SERVICE BULLETIN

MODEL NAME : Di620
MODEL CODE : 1155
NO. : 035
DATE : 990602
SUBJECT : CHANGE OF CABLE MOUNTING BRACKET

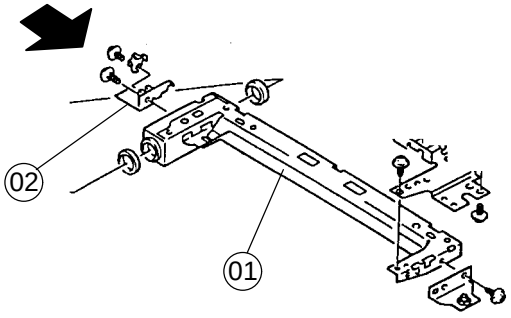
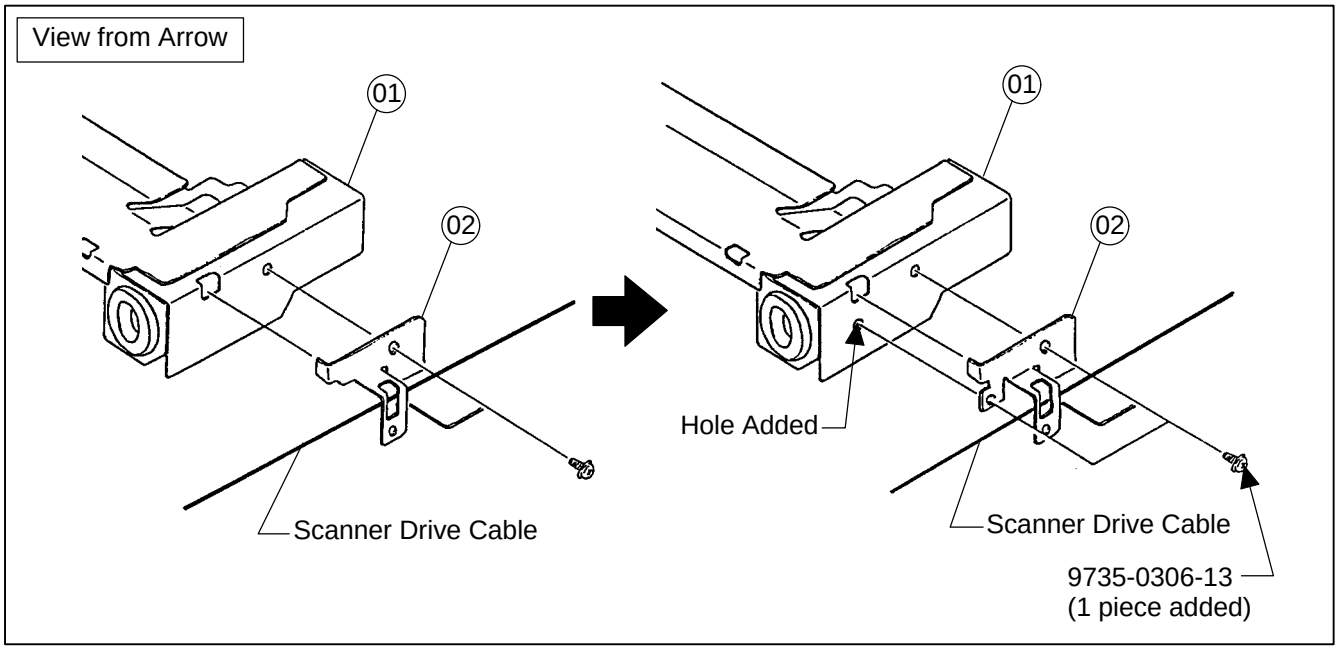
PROBLEM: The Cable Mounting Bracket (02) installed on the Scanner Assy (01) can at times be broken.
CAUSE: When the Scanner is moved, the Scanner Drive Cable interferes with the Cable Mounting Bracket (02), causing the Cable Mounting Bracket (02) to wear.
SOLUTION: The following changes have been made to increase the strength of the Cable Mounting Bracket (02).
-The shape of the Cable Mounting Bracket (02) has been changed.
-A Screw hole has been made in the Scanner Assy (01).
-As a result of the change made in the shape of the Cable Mounting Bracket (02), a tapping screw (9735-0306-13) has been added.

NOTE: The new Bracket (02) must be installed in premodification machines with the new 1st Slider (01).
